**Addendum:
WATER QUALITY MONITORING AND ASSESSMENT
HYDROGEOLOGICAL ASSESSMENT
Proposed Drainage District #88**

Report to the Dodge County Circuit Court

July 19, 2011

Re: Montgomery-Settersten Report on Proposed Dodge County Drainage District 88

Figure 1. Gravel Pits at Historic DCAPC Site

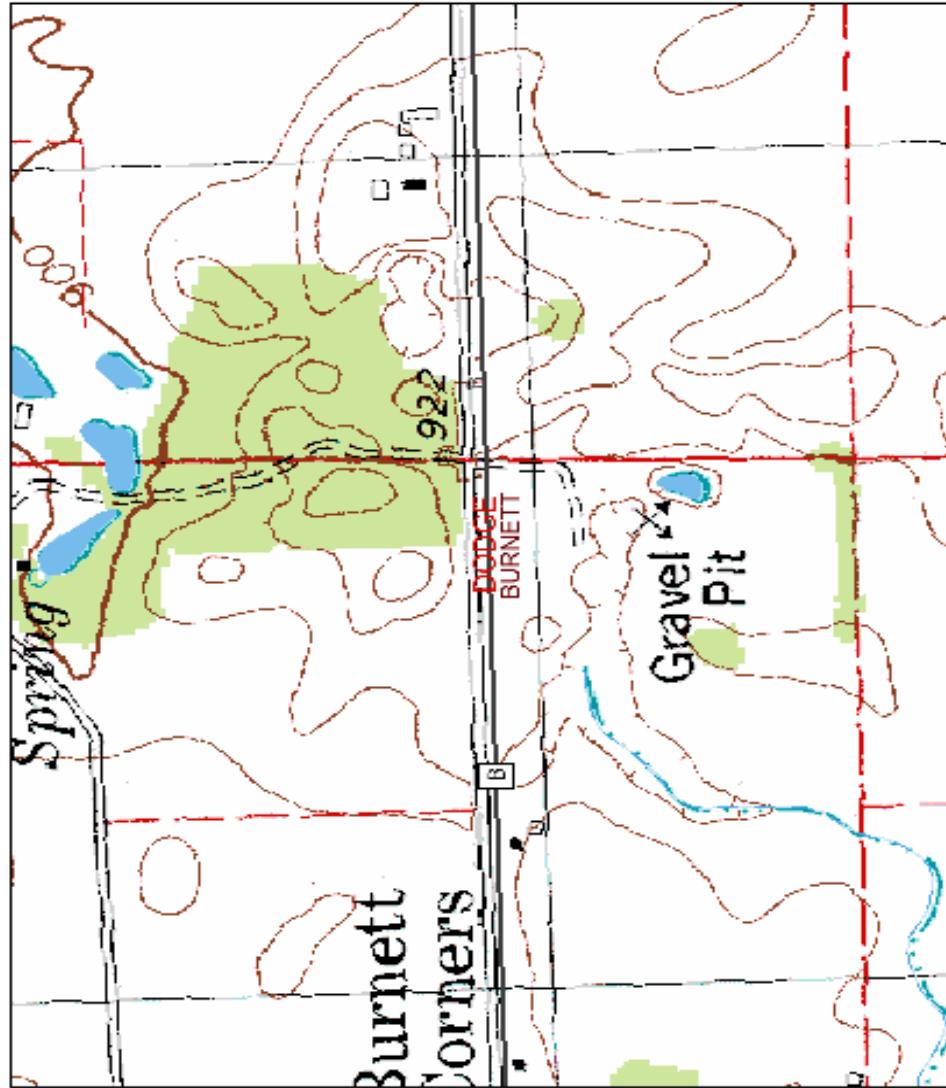
Figure 1 is an archival topographic map of the historic DCAPC site with the gravel pit area clearly identified. The area was about 5 acres in size with two large pits. The map also shows the path of overland flow terminating on site. The authors of the Report appear to have either overlooked this information or not considered its significance.

The Report also concludes that it “... *is unlikely that the club property, including area surrounding the former gravel pits, would have had substantial impact on flood discharge*” We believe a more thorough examination of the evidence supports the conclusion that filling and development of DCAPC grounds eliminated the natural retention basin and reduced substantially infiltration of storm water flowing to the site. Significant alteration of the natural hydrologic pattern within lands up-gradient as a result of agricultural production and ditching has caused an increase in runoff to

Figure 3. Method Detection Limit (MDL) and Wisconsin standard for surface waters for phosphorus (as total P). Phosphorus values within the red zone exceeded the state standard of 75 $\mu\text{g/L}$, while values within the green zone are at or below the state standard.

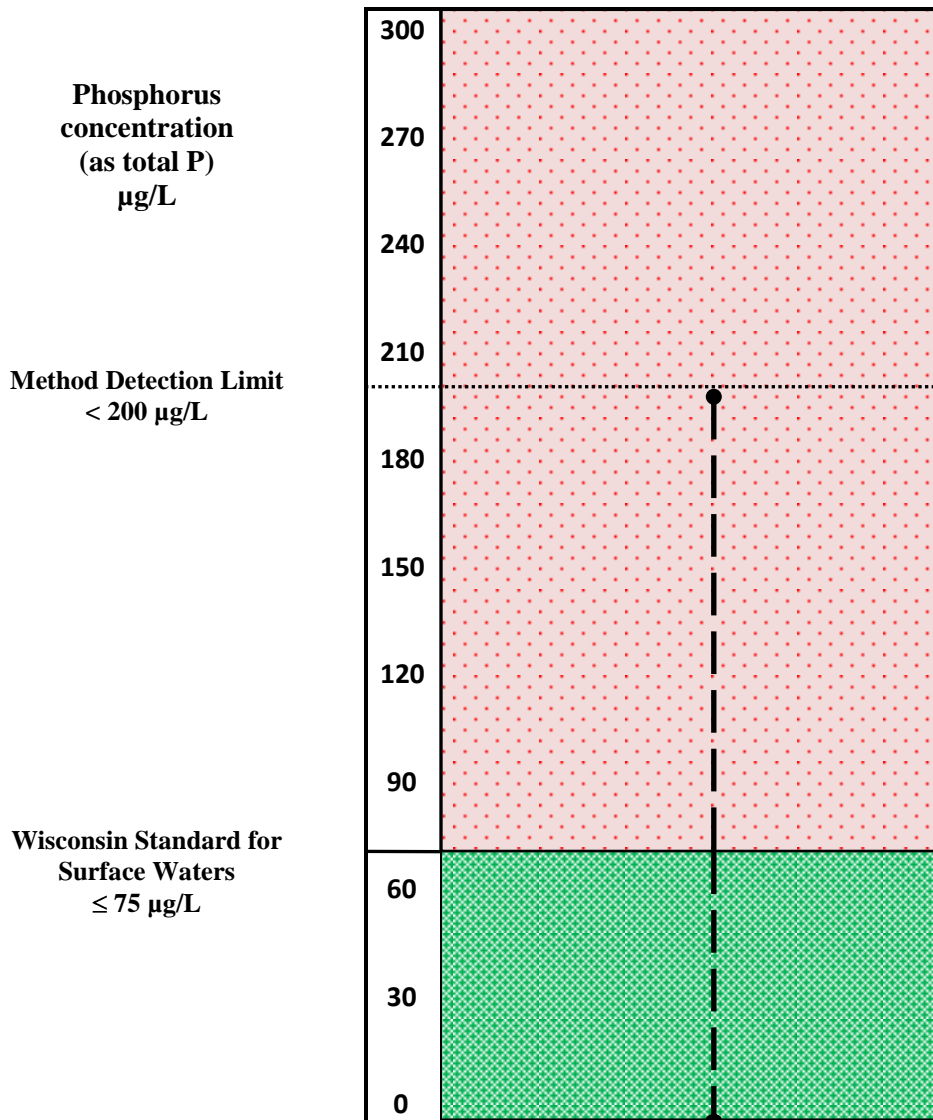
The relevance of MDL in assessing water quality may be demonstrated by Figure 3. Shown on the Y axis with phosphorus concentration in $\mu\text{g/L}$ are the Method Detection Limit of $< 200 \mu\text{g/L}$ and the Wisconsin standard for phosphorus in surface water of $\leq 75 \mu\text{g/L}$. The vertical dashed line covers the range of phosphorus values that are less than $200 \mu\text{g/L}$. Note that the federal definition of MDL with 99 % confidence means that a sample with phosphorus assay as high as $199 \mu\text{g/L}$ must be reported as $< 200 \mu\text{g/L}$.

Figure 4. (below) Phosphorus Concentrations ($\mu\text{g/L}$) at Drainage District 88 Sampling Sites, Spring, Pond, River and Lake

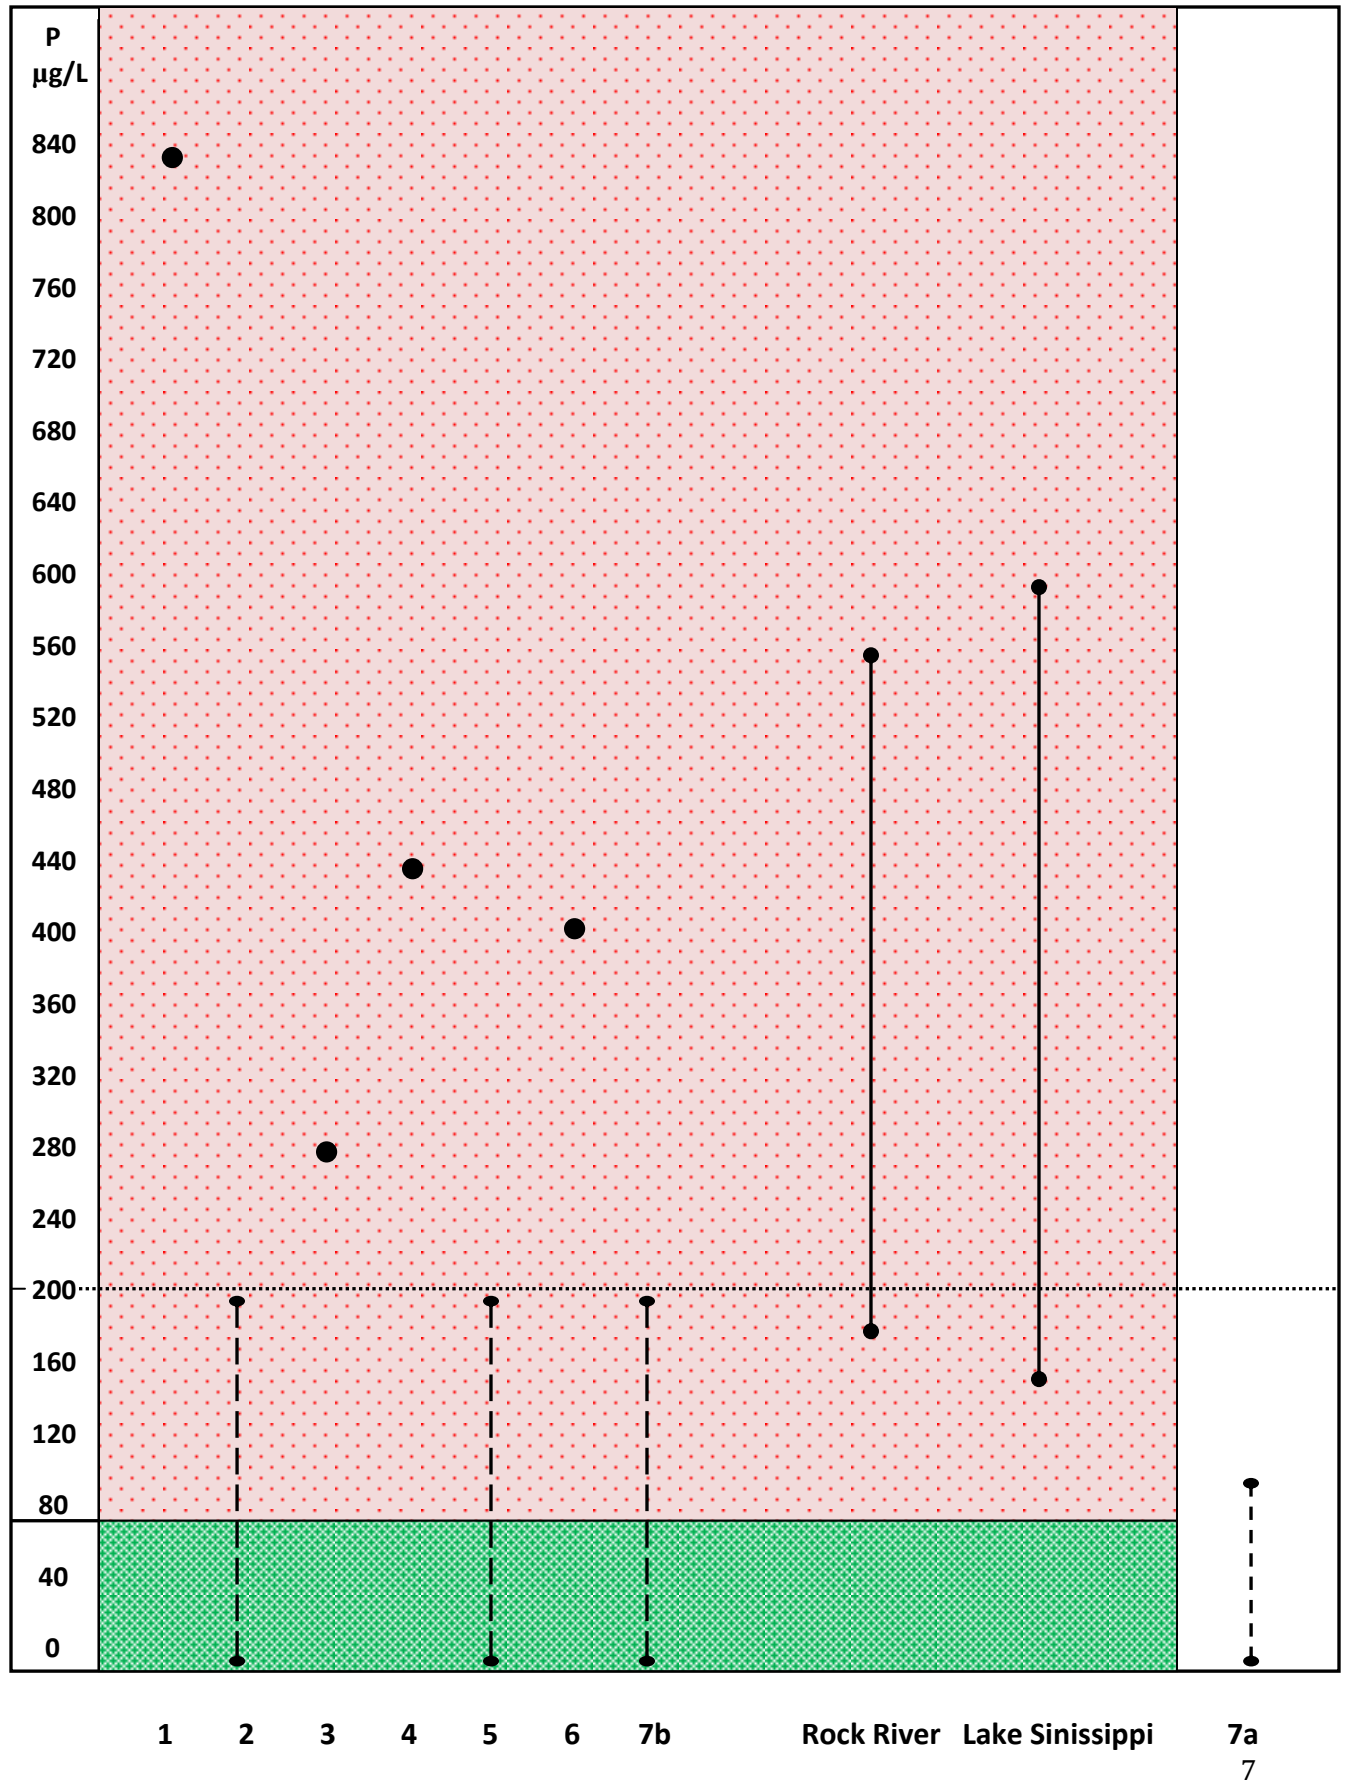
Phosphorus values given in the Lake District water quality report on District 88 are shown in Figure 4, along with the range of phosphorus concentrations in the Rock River and Lake Sinissippi as reported by the US Geological Survey and the Lake District. Sampling site 7a is the spring water (ground water) that flows into the first pond at Spring Brook Farm. The MDL indicates that the value of phosphorus in a sample reported as $< 200 \mu\text{g/L}$ is likely to exceed the state standard, since the probability of the true value exceeding the state standard (red zone) is greater than the probability of the value being at or below the standard (green zone).

The data clearly demonstrate that there is a phosphorus problem in district drain waters. The sample from Site 1 is in excess of 1,100 % of the state standard. Additionally, the magnitude of the reportable values (*i.e.*, those values greater than the MDL) strongly suggest that the true value of samples reported as being below the MDL would likely fall very close to the MDL, especially since the lowest reportable datum of $260 \mu\text{g/L}$ is 347 % greater than the state standard.

Figure 5. Total nitrogen concentrations (mg/L) at Drainage District 88 Sampling Sites and Spring Pond.

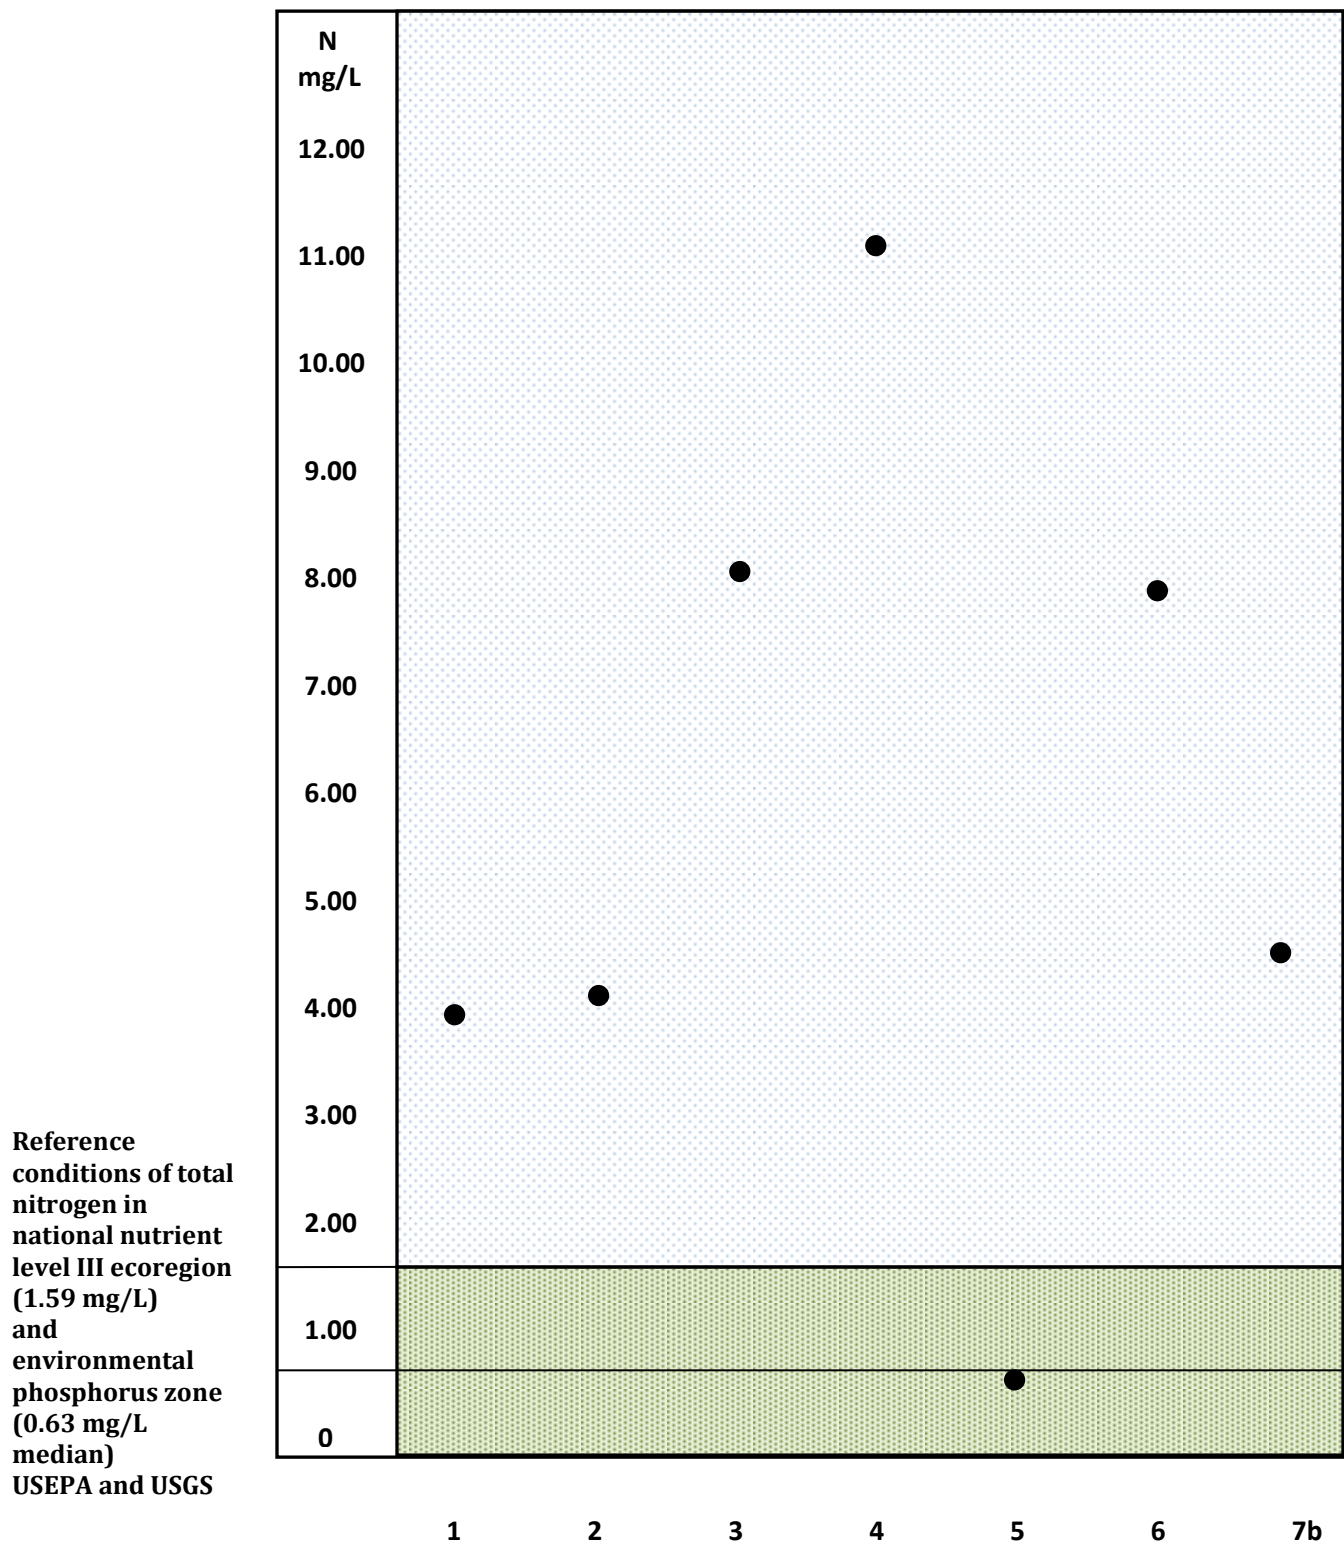
Nitrogen values in samples collected in the proposed district are shown in Figure 5. On the Y axis are values of total nitrogen (total Kjeldahl nitrogen plus nitrate and nitrite nitrogen) in mg/L at each sampling site. Also shown are the reference concentrations for total nitrogen in national level III ecoregion 53 (1.59 mg/L) and environmental phosphorus zone 2 (0.63 mg/L) (Sources: US Environmental Protection Agency 2000 and Robertson, D M *et al*, 2006). Nitrogen values in drain water of the proposed district dramatically exceed federal reference conditions. The sample from Site 4 is 700 % of the reference value. (Given the high nitrogen values in the other samples, the low value at site 5 is probably an anomaly; however, there was an insufficient volume of water available for a re-test.)

The Rock River and Lake Sinissippi are on the EPA 303(d) list of impaired waters for reason of nutrient enrichment and both are under state management plans to correct deficiencies and reduce phosphorus and nitrogen values. The message of Figures 4 and 5 is that unless and until nutrient loads in watershed runoff, such as that from proposed District 88, are reduced substantially, the Rock River, Lake Sinissippi and other surface waters will remain seriously impaired.
